CCL 13/12/2022 – TOOKE STREET, COOKS HILL – PEDESTRIAN FACILITY UPGRADES

ITEM-112 Attachment A: CCL13122022 – Tooke Street, Cooks Hill –

Proposed Upgrade Plan

SUMMARY OF SUBMISSIONS - TOOKE STREET, COOKS HILL - STORMWATER AND PEDESTRIAN UPGRADES

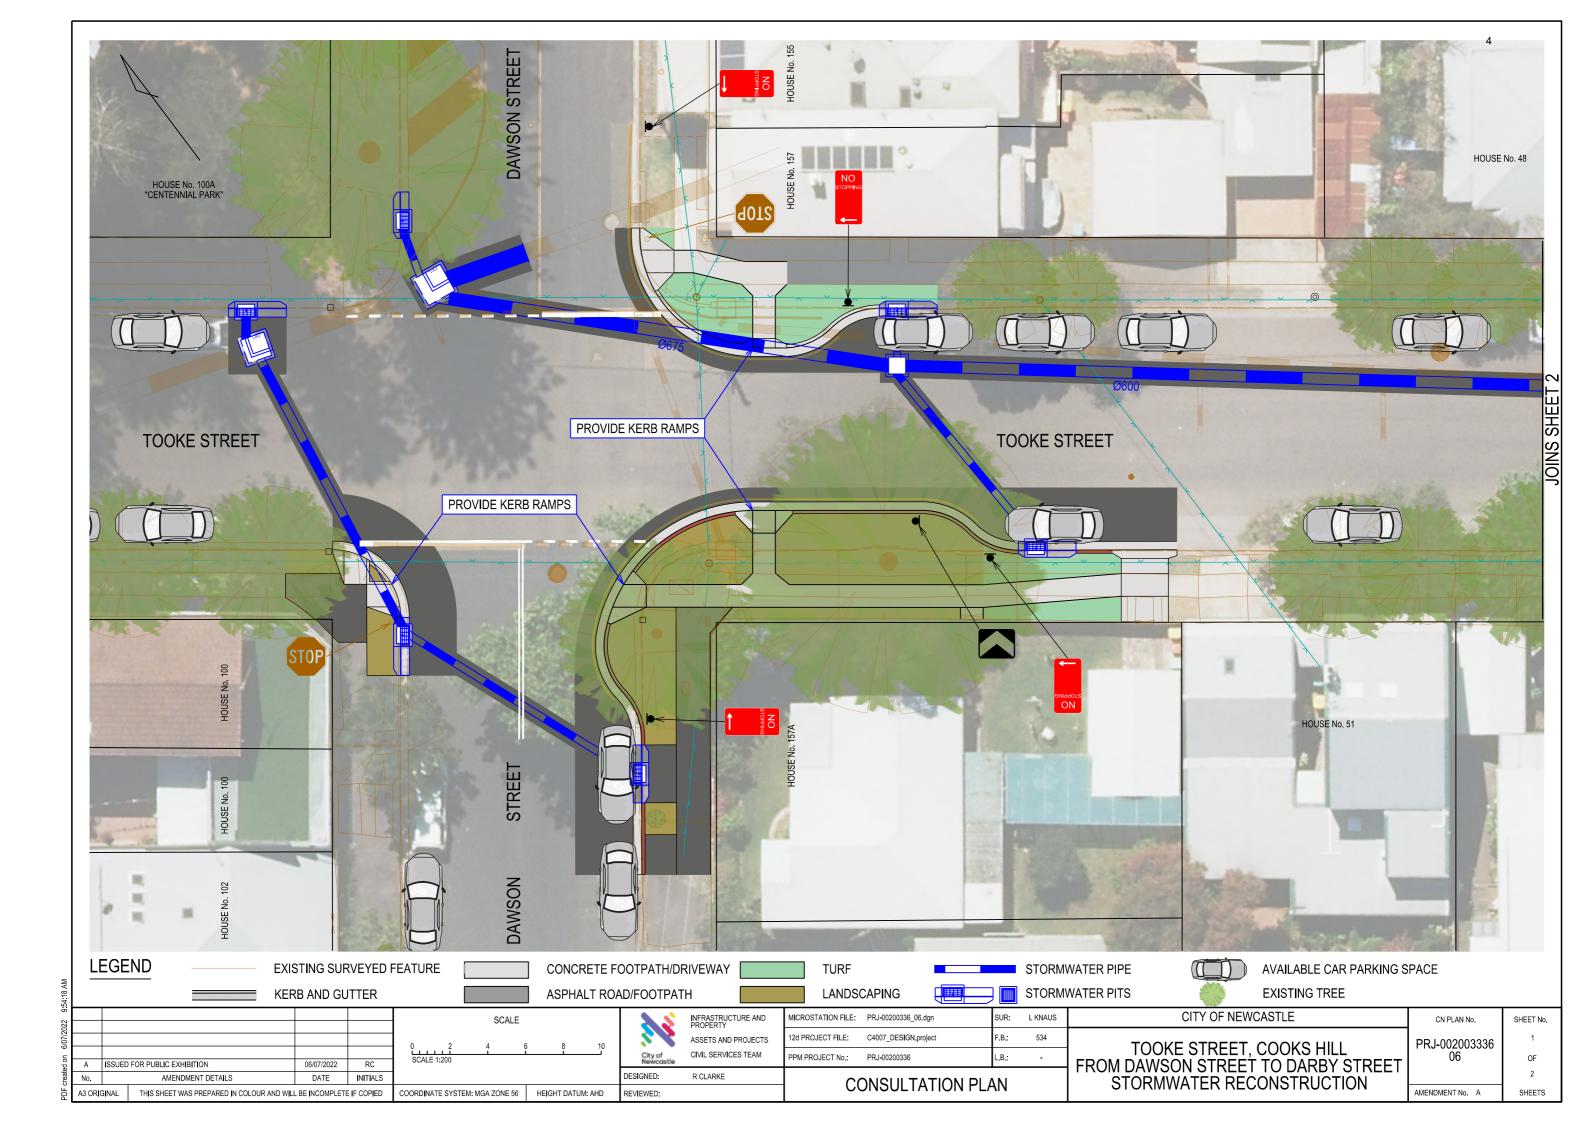
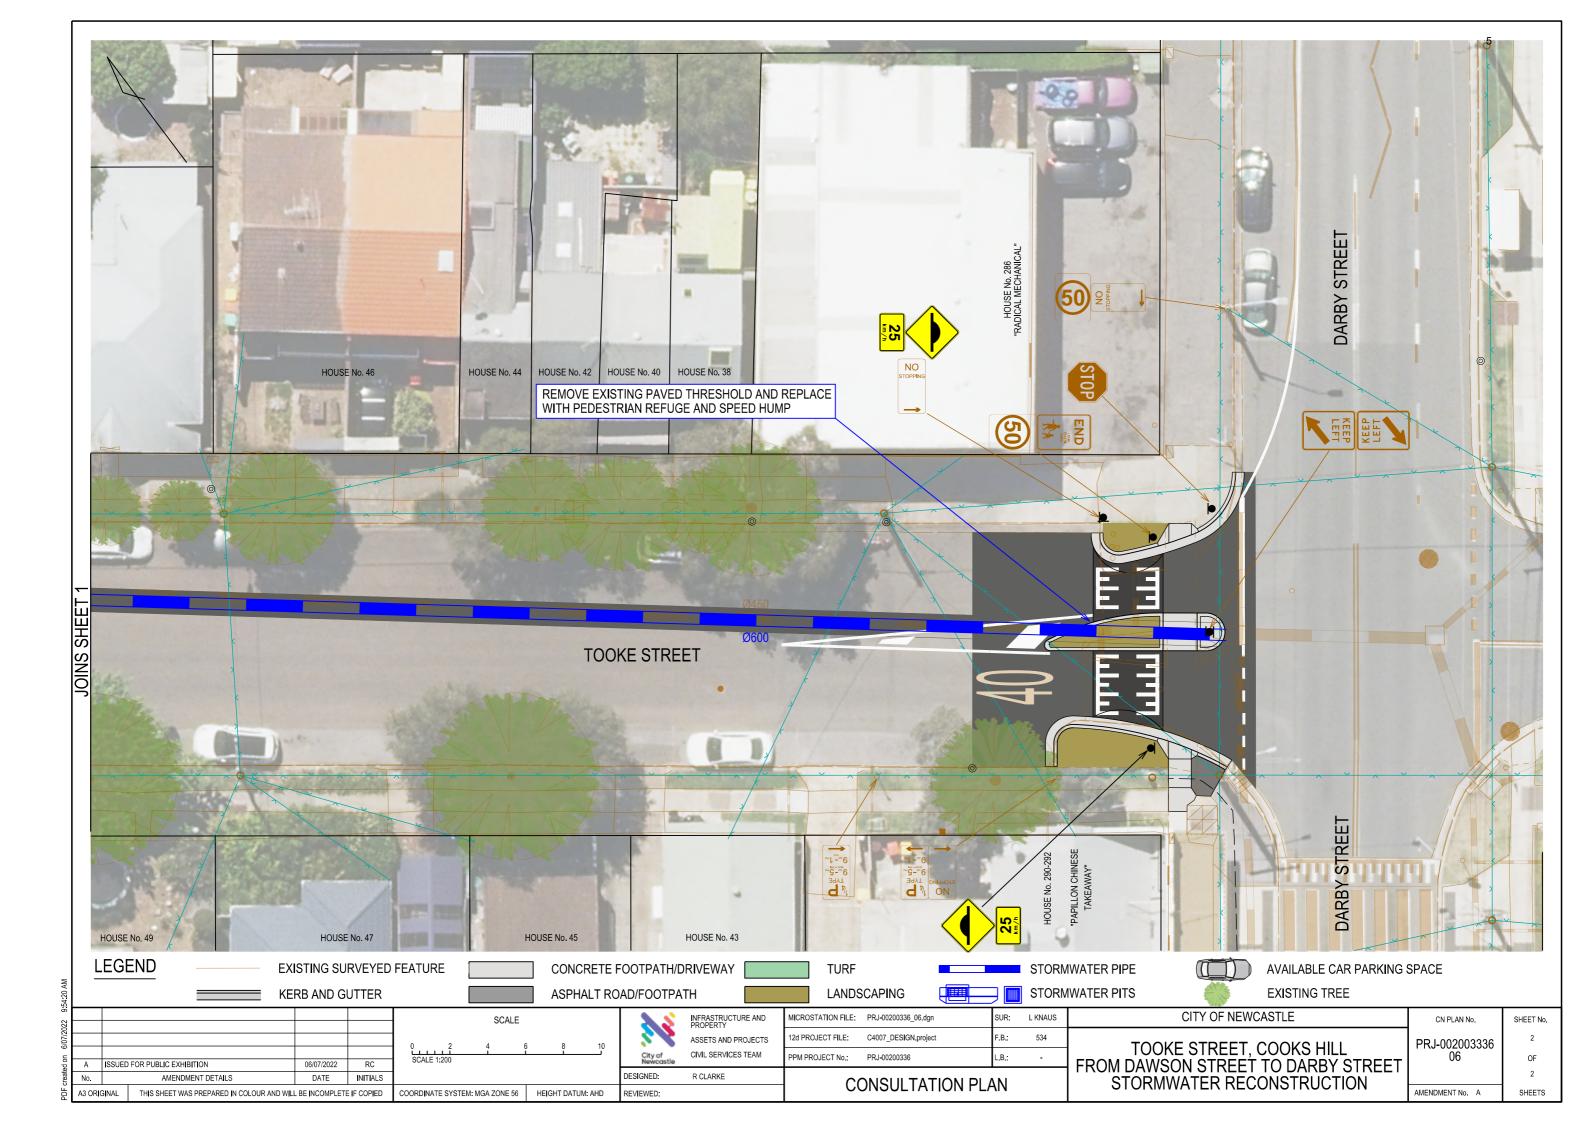
No.	Document Date	Suburb	Support	Summary of Submission	CN Response
1	23/07/22	Hamilton NSW 2303	Yes		
2	29/07/22	Warners Bay	Yes, with changes	Respondent recommends continuous footpath treatment for Darby Street intersection. Respondent supports the kerb extensions and ramps but fears poor design could lead to steep gradients on the ramps. Respondent requests similar kerb extension for the two corners on the west side of the Dawson Street and Tooke Street intersection	Continuous footpath treatments were considered. However, due to constraints in the space, issues with storage for turning vehicles and the traffic volumes (greater than limits recommended by TfNSW for continuous footpath treatments) were no pursued. The kerb ramps have been designed to standard with close consideration of useability. Kerb extensions for the other corners were considered but not prioritised at this time.
3	01/08/22	Cooks Hill	Yes, with changes	Respondent supports the works and recommends that pedestrian improvements are made to the intersection of Corlette Street and Tooke Street	Noted. Corlette Street is outside the scope of this project. It could be considered for future LATM works.

4	04/08/22	Cooks Hill	Yes, with changes	Respondent recommends that maintenance of the footpath on the eastern side of Dawson Street between Tooke Street and Young Street be considered	This is outside the scope of this project. However, the request will be passed on to the Assets management team

No.	Document Date	Suburb	Support	Summary of Submission	CN Response
5	05/08/22	Cooks Hill	Yes, with changes	Respondent recommends a pedestrian crossing facility on the Northeast of the Tooke/Darby Street intersection	This pedestrian crossing is outside the scope of this work. However, it may be considered in the pedestrian program in the future
6	09/08/22	North Lambton	Yes		
7	13/08/22	Cooks hill	Yes, with changes	Respondent believes that the intersection of Parry Street with Dawson Street has worse flooding that the project area	This issue is outside the scope of the works, noting the works are in detailed design. The issues raised at Parry Street to be passed onto the Stormwater team
8	23/08/22	The Hill, Newcastle	Yes, with changes	Respondent recommends a bend out design across Tooke Street at Darby Street. It was also noted the importance of consistency between thresholds and the issues with the current threshold in Bull Street.	This design was considered. However, due to a driveway for the mechanic close to the current threshold, there were constraints on this design. LATM and local centre upgrade work will ensure that consistency between thresholds is maintained where possible.
